Access Compliance Report

Public Rights-of-Way

| Intersection ID: 29271 | Main Street: IRON_BRIGADE_LN | Cross Street: LAKOTA_CT | Location: S |
| ADA ID: 6B24EC24E218 | Ramp Type: PerpDiag | Initial Pass/Fail: Fail | Overall Compliance: No |

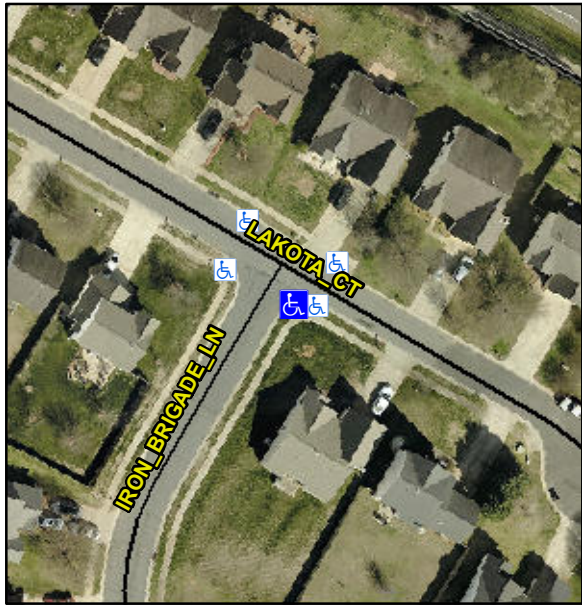
R304.5.1, R304.2.2, R304.5.3

| Compliance | Description | Data | Compliance | Description | Data |
|------------|-----------------------|------|------------|-----------------------------|------|
| N/A | Ramp Length (in) | 45.0 | No | Ramp Slope (%) | 13.7 |
| No | Ramp Width (in) | 43.0 | No | Ramp XSlope (%) | 8.7 |

Remove & Replace Curb Ramp With Two New Directional Ramps or Equivalent.
